GTR Phase 2 on FCEV
Brussels, Belgium
October 16-18, 2018

TF5 ISO/TC 197 Recommendations
Interface Topics for Consideration

Andrei V. Tchouvelev

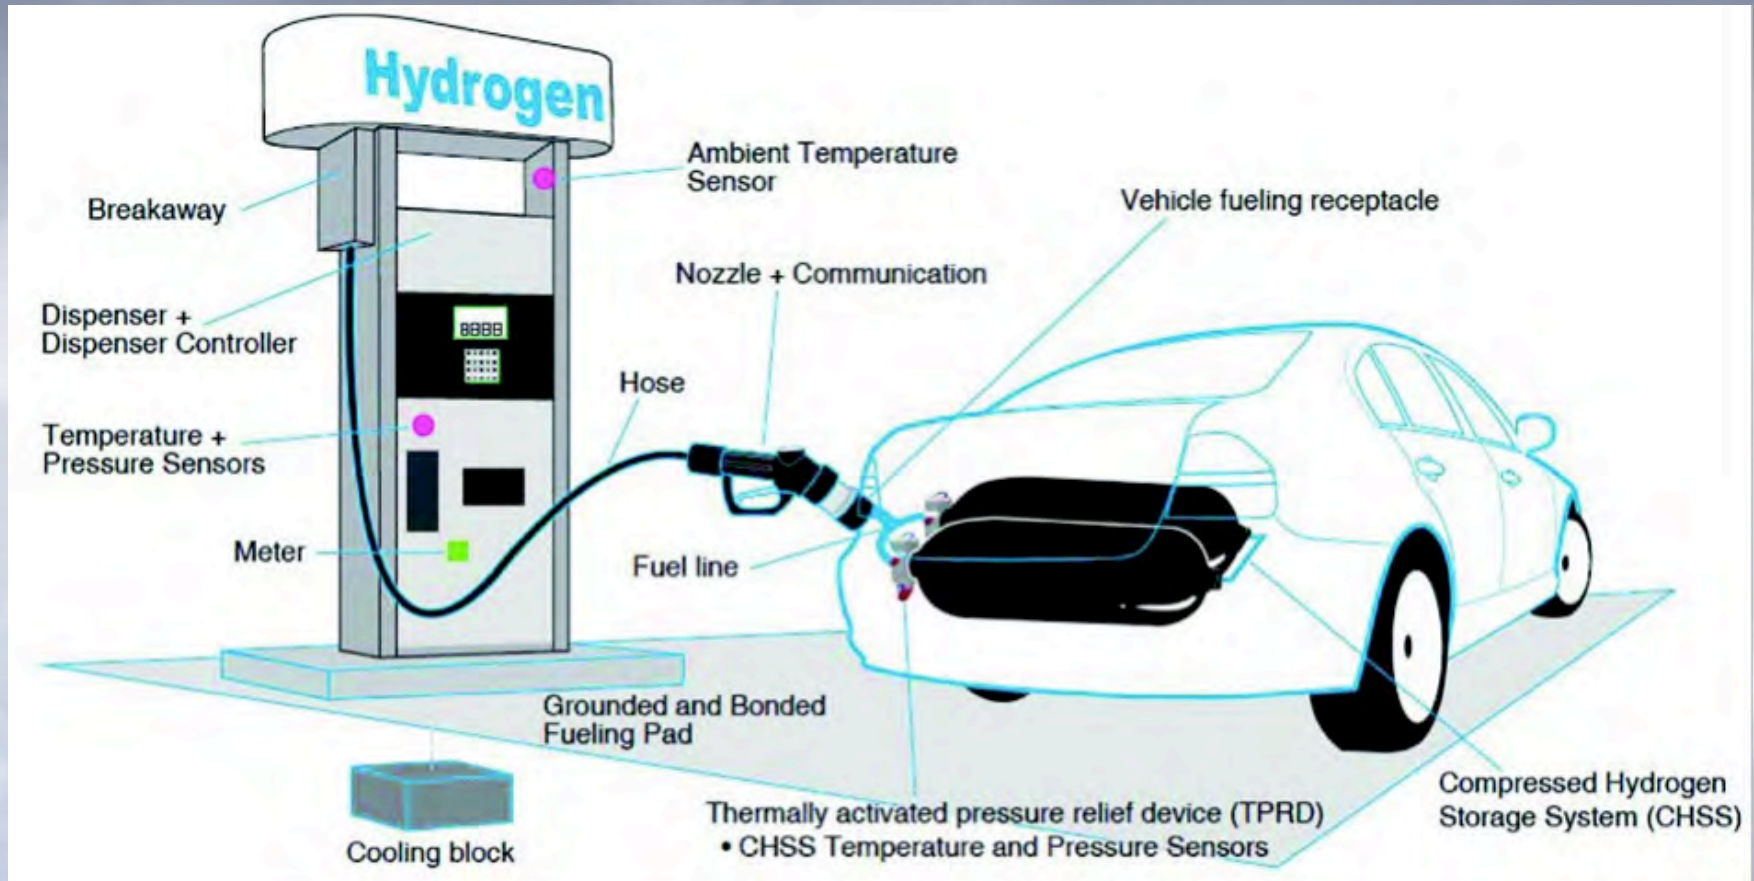
It makes sense inserting into Preamble the above image explaining the key interoperability features of Station – H2 vehicle interface.
